# IDAP REPORT – SECTION 4.55(1A) MODIFICATION

31 The Crescent, Homebush	
Property:	LOT A DP 391764	
	DA2018.67.4	
	Section 4.55(1A) modification application to	
Proposal	increase the height of the lift over-run by 600mm	
Proposal:	and revise material finishes including exposed	
	slab to brick façade.	
Applicant:	Urbanlink P/L	
Owner:	Richard Nader	
Date of lodgement:	27 April 2022	
Notification period:	10 May 2022 – 24 May 2022	
Submissions received:	Nil	
Assessment officer:	W van Wyk	
Estimated cost of works:	\$5,624,491.00	
Zoning:	B4-Mixed Use - SLEP 2012	
Heritage:	Local Heritage Item 'I44' adjoins the site	
Flood affected:	Yes	
RECOMMENDATION OF OFFICER:	APPROVAL

Figure 3: Proposed Modified Roof Plan – DA 2018/67/4

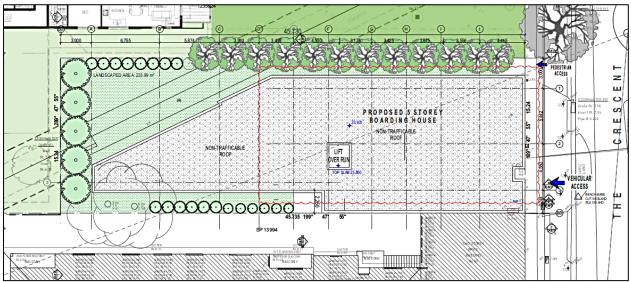
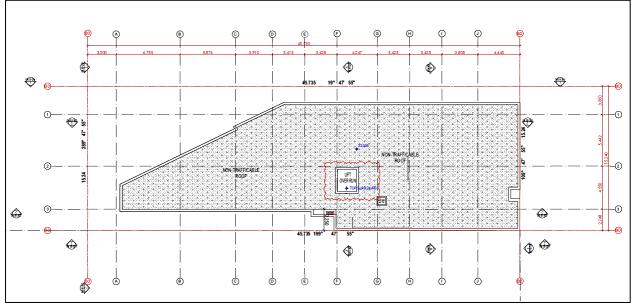
• Lift overrun extended by 600mm to a total of 900mm above the roof height.

The proposed height increase is for the lift over-run only which will not be readily visible from the public domain. The scale of the approved development is maintained. The revised lift will continue to adequately service the density and capacity of the development. This has been demonstrated in a lift analysis submitted with the application. Accordingly, the height variation is considered consistent with the objectives of the standard and is acceptable.

Figure 5: Proposed East Elevation – DA 2018/67/4

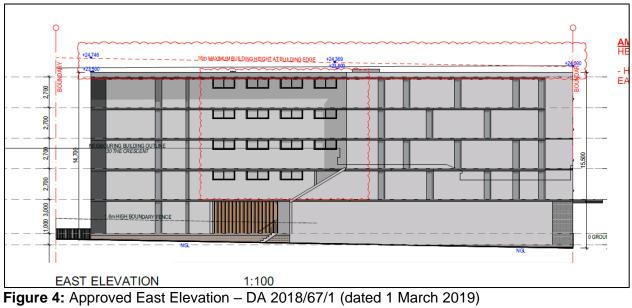
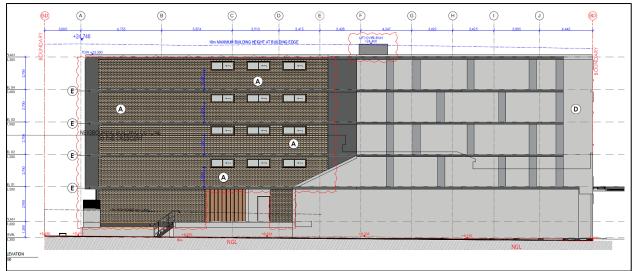
- Facades amended to incorporate exposed slab horizontal element on each level. The approved facades were only facebrick (refer to **Figures 4-11**);
- Shopfront window and door amended to reflect the business/shop uses anticipated by Condition 7; and
- Eastern elevation to provide three rather than four highlight windows servicing the communal corridors.

The proposed modified elevations will retain a similar colour range and appearance to what has been approved. While the exposed slabs add visual interest, this will not create a stark contract with the heritage item. Accordingly, the proposed modified elevations will not detract from the significance of the heritage item and are consistent with Part P of the SCDCP.

Figure 9: Proposed North Elevation – DA 2018/67/4

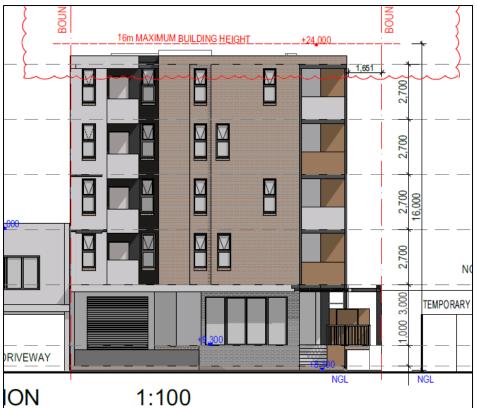
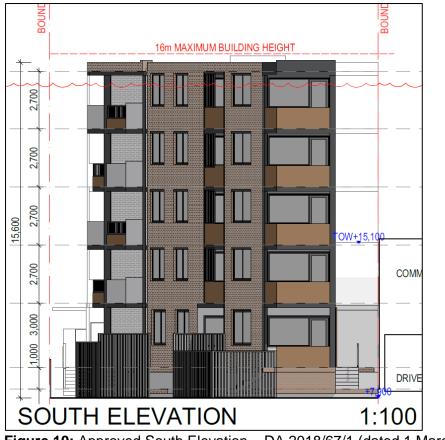
A significant portion of each façade is retained as facebrick which is in keeping with the dominant building material of the locality. The addition of exposed slab elements provide a stronger horizontal element which assists in breaking up the built form and providing visual interest (refer to **Figures 14 and 15**; note some changes to the ground floor were approved through a CC). Accordingly, the proposed material changes will improve the overall quality of the streetscape.

Figure 13: Section showing height of lift over-run

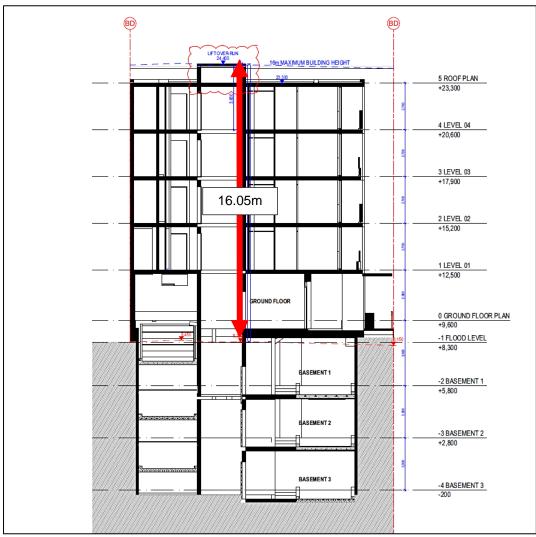
The original development application was refused because, inter alia, the height limit was breached and the Clause 4.6 variation was not well founded. The design was subsequently amended to reduce the height to comply with the 16m development standard. This included removing the rooftop terrace, lowering the floor to ceiling heights and lowering the lift overrun. It is now proposed to extend the lift over-run again which will breach the height limit by 16.05m (0.3%) as measured to the Ground Level (Existing) immediately below (refer to **Figure 13**).

The height variation is negligible, being a 0.05m or 0.31 % variation to the development standard. The negligible nature of this variation means that this will not be perceptible as a variation when viewed by the casual observer. Further, the scale of the variation and the setback of the lift overrun from the perimeter of the built form will limit potential visibility of the lift overrun itself from surrounding areas. Accordingly, the perceptible height will be readily compatible with the existing area as it will present as appropriately responding to the current planning controls.
